Hybrid permission APP/12/00338 & Section 73 permission APP/15/00732

Environmental Statement Volume 1

Chapter 14 Landscape & Visual Assessment & Figure 4.3 Parameter Plan 3

Plot 2 update & revision

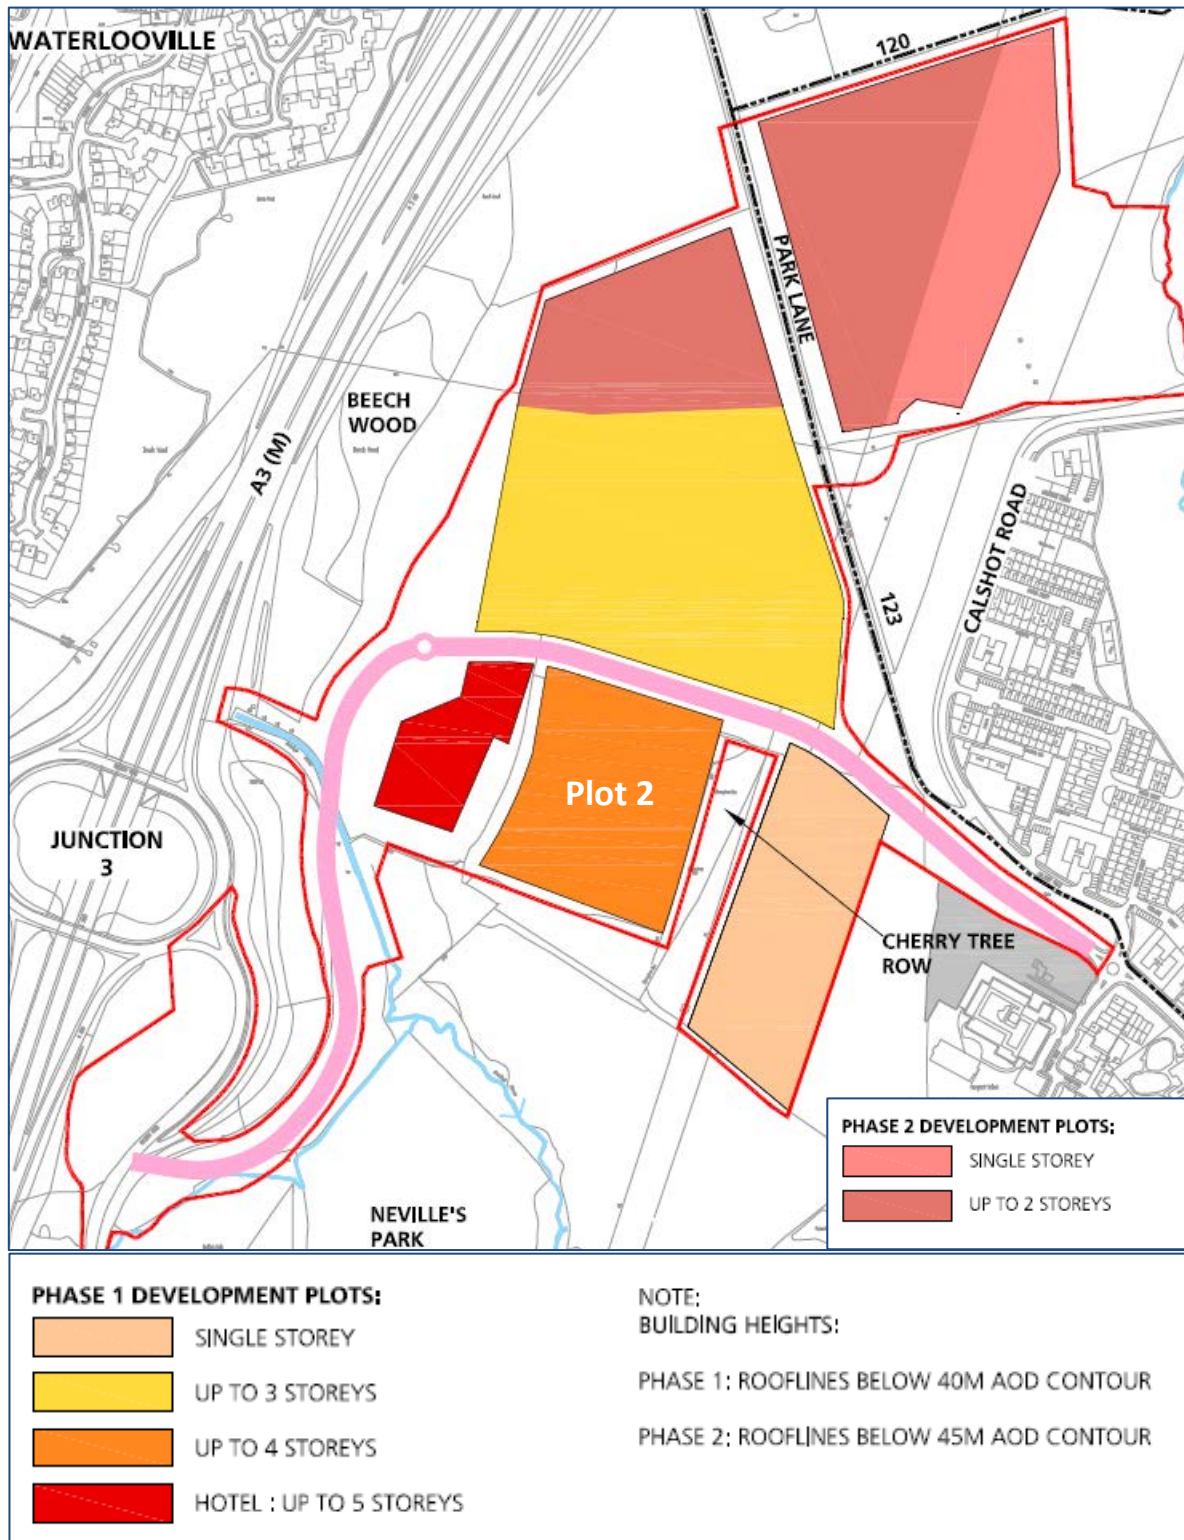
- 2.7 As the extract from Parameter Plan 3 overleaf demonstrates, the screening effect of Beech Wood would be most applicable to the Phase 1 areas north of the link road, where the

development plots are restricted to 3 storeys (Phase 1) and 2 storeys (Phase 2). Plot 2 to the south of the link road has the added screening on three sides of the plot within the DHF site itself, hence the higher 4 storey limit.

- 3.1 Parameter Plan 3 proposed a building height of 4 storeys on this plot, with a **+40.0m AOD** roofline (Phase 1 development). The apex of the curved roof of the proposed building in the reserved matters application sits at **+42.0m AOD**, the eaves at **+40.5m AOD**. We therefore seek a revision to the Note on Parameter Plan 3 for Plot 2 only to increase the roofline to **+42.0m AOD**.
